August 19, 2002

SUBJECT: WORKPLAN ADDENDUM FOR ADDITIONAL SUBSURFACE SITE ASSESSMENT AT THE MISSION VALLEY ROCK COMPANY FACILITY LOCATED ON 7999 ATHENOUR WAY, SUNOL, CALIFORNIA

FIGURE 1

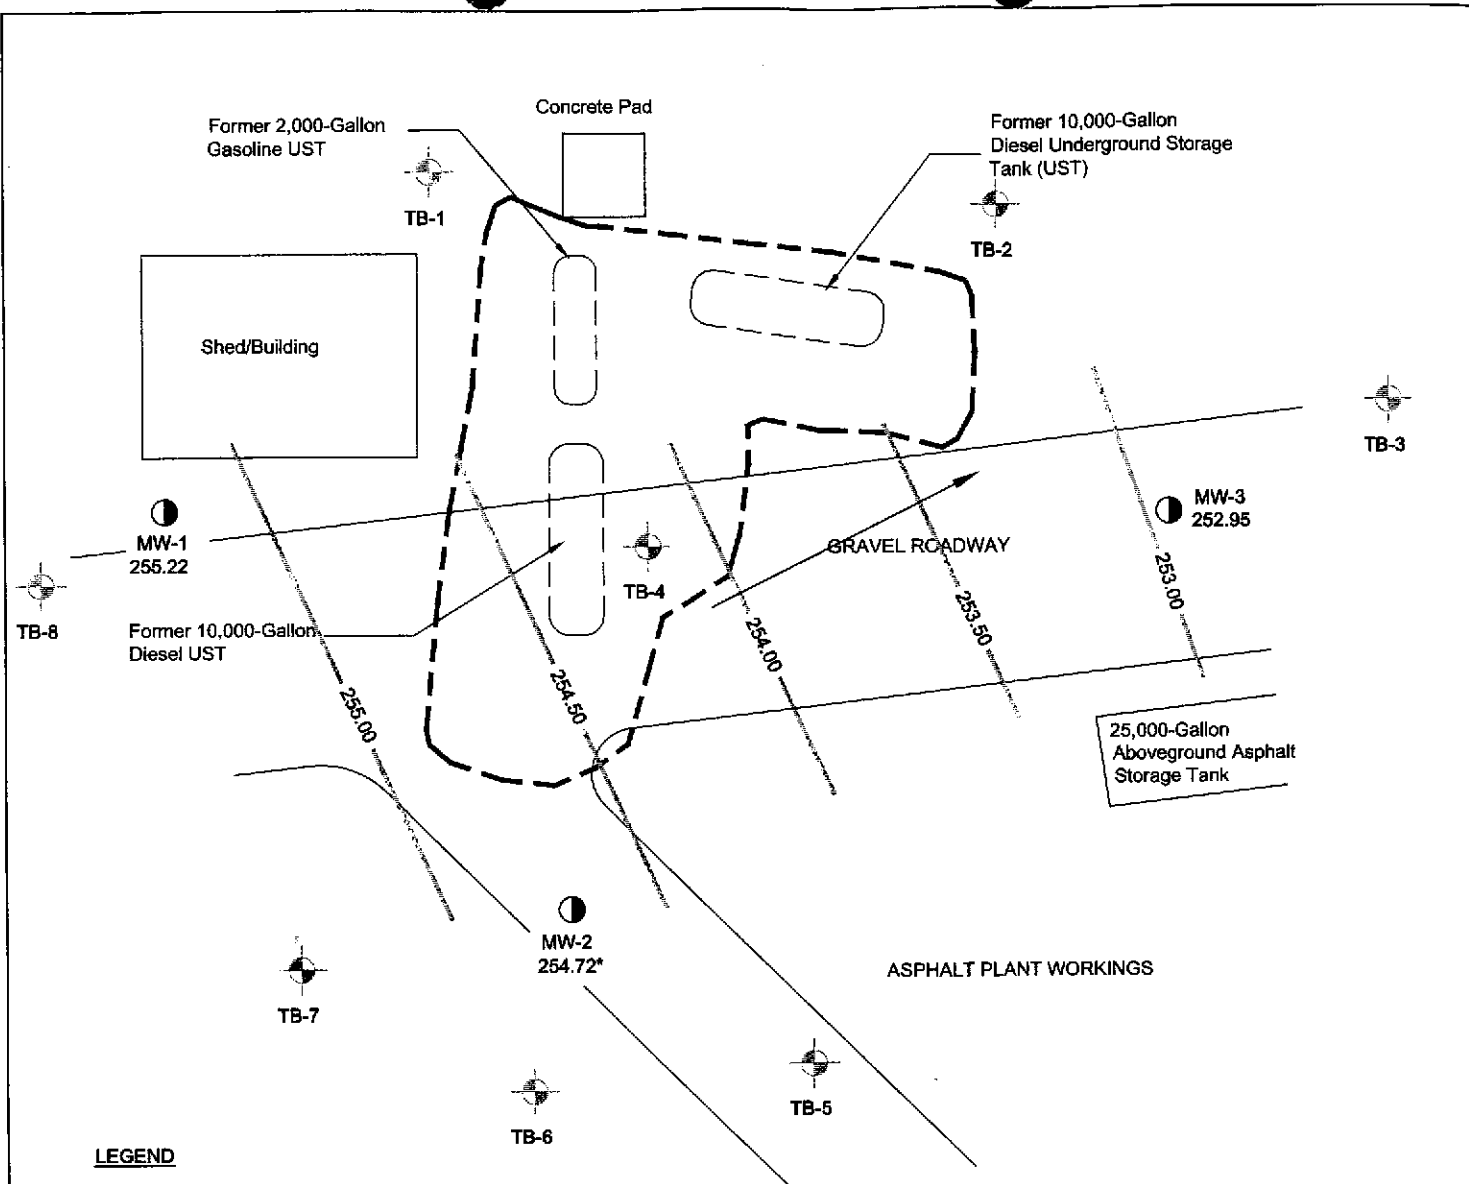
This addendum addresses the change of scope that was recommended by you during a phone conversation on July 7, 2002. Instead of using hollow stem augers and setting three (3) groundwater monitoring wells you recommended the use of "rapid site assessment tools" (e.g. GeoProbe®) for the additional site assessment.

Eight (8) soil borings will each be driven throughout the Site using GeoProbe® technology. The proposed boring locations are shown on Figure 1 (attached). The eight (8) borings will be drilled to a depth of approximately 25 feet below ground surface (bgs). Samples collected from the borings will be used to assess the vertical and lateral impact in the soil. A TEM geologist, trained and supervised by a California Registered Geologist, will describe soil samples using the Unified Soil Classification System (USCS).
